# Access Compliance Report

### (Curb Ramps)

Intersection ID: 31473	Main Street: ALSTON_HILL_DR	Cross Street: EMERALD_FERN_WY	Location: SW
ADA ID: 7845AB00971A	Ramp Type: Perp	Initial Pass/Fail: Fail	Overall Compliance: No
		Severity Score: 12.5

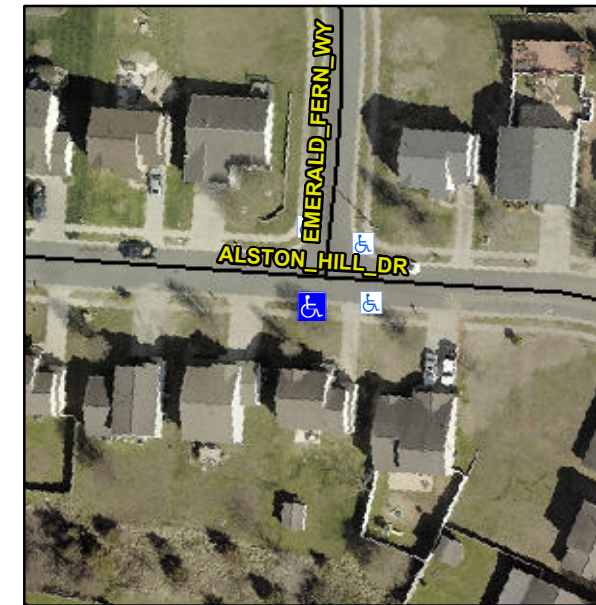
**Not Found, R304.5.3**

Compliance	Description	Data	Compliance	Description	Data
N/A	Ramp Length (in)	47.5	Yes	Ramp Slope (%)	6.9
Yes	Ramp Width (in)	48.0	No	Ramp XSlope (%)	5.8
N/A	Flare Type LT	N/A	N/A	Flare Type RT	N/A
N/A	Flare Slope LT (%)	N/A	N/A	Flare Slope RT (%)	N/A
N/A	Flare Traversable LT?	N/A	N/A	Flare Traversable RT?	N/A
N/A	Landing Length (in)	N/A	N/A	DWS Provided?	N/A
N/A	Landing Width (in)	N/A	N/A	DWS Contrast?	N/A
N/A	Landing Slope (%)	N/A	N/A	DWS Length (in)	N/A
N/A	Landing X Slope (%)	N/A	N/A	DWS Full Width?	N/A
N/A	Landing Curb? (Y/N)	N/A	N/A	DWS Offset (in)	N/A
N/A	Shared Landing?	N/A			
N/A	Gutter Ponding?	N/A	N/A	Gutter Slope (%)	N/A
N/A	Gutter Lip Ht (in)	N/A	N/A	Gutter X Slope (%)	N/A
N/A	Painted X Walk1?	No	N/A	Painted X Walk2?	N/A
	X Walk 1 Direction	To N		X Walk 2 Direction	N/A
N/A	X Walk 1 Width (in)	N/A	N/A	X Walk 2 Width (in)	N/A
	X Walk 1 Slope (%)	2.7		X Walk 2 Slope (%)	N/A
	X Walk 1 X Slope (%)	5.2		X Walk 2 X Slope (%)	N/A

**Remove & Replace Entire Ramp.**
